Flight Procedures Cover Page	Task Action: FLIGHT CHECK	Task Type: IAP	Estimated Chart Date: 03/19/2026	APWS Task ID: 77B3243723074B3096D9B8ADAC5991C3	APWS Project ID: 8C73EA28107748F38C460FE463A9F25D
Procedure: RNAV (RNP) Z RWY 8L AMDT 4A		Enroute: NO	Specialist: Donkor, Kweku		Agreement Number:
Airport ID: PHNL			Airport City: HONOLULU		State: HI
Facility ID:	Facility Type:	Flight Inspection Remark Type: New FC Slot

Date: 12/06/2023  
To: Wade Terrell, Manager, Flight Technologies and Procedures Division THRU:  
Wayne Radicke, Manager, Flight Procedures and Airspace Group  
From: Julie Morgan, Manager, Team 1, AJV-A41  
Subject: Approval Request: DANIEL K INOUYE INTL (PHNL), RNAV (RNP) Z RWY 8L

RNAV (RNP) Z RWY 8L  
DANIEL K INOUYE INTL HONOLULU HI (PHNL)

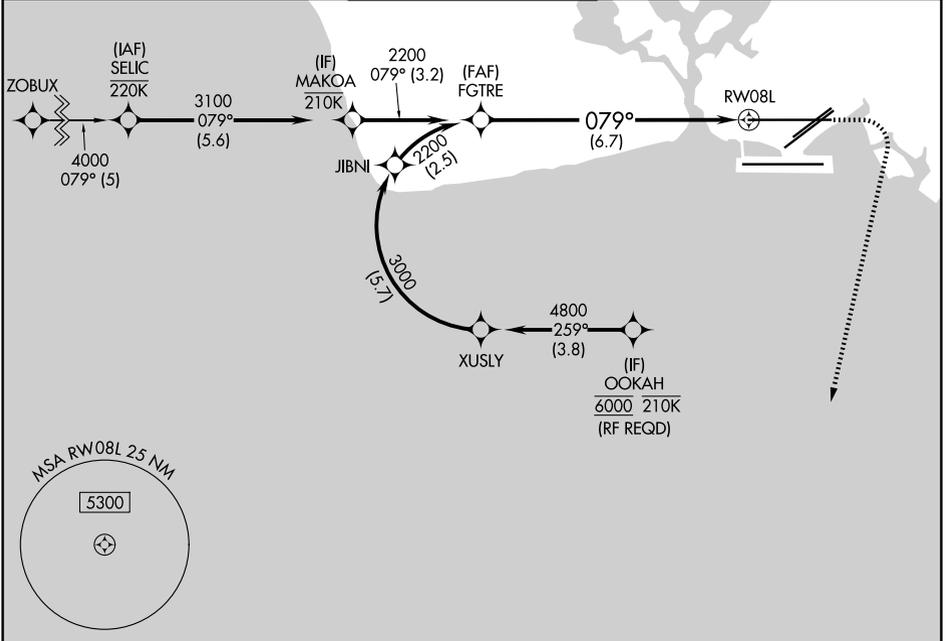
PHNL TRACON requests AFS approval to retain the currently charted mandatory altitude restriction at the following fix: OOKAH at 6000ft MSL for RNAV (RNP) Z RWY 8L instrument approach procedure for DANIEL K INOUYE INTL (PHNL).

Currently, FAAO 8260.19l paragraph 8-6-10n (1) requires Flight Standards approval from the Flight Technologies and Procedures Division to chart a mandatory altitude on the intermediate segment of an instrument approach procedure.

Therefore, PHNL TRACON requests to retain the currently charted mandatory altitude at OOKAH RNAV (RNP) Z RWY 8L. This is an ATC operational request to ensure vertical separation between aircraft on the approach and other TRACON traffic.
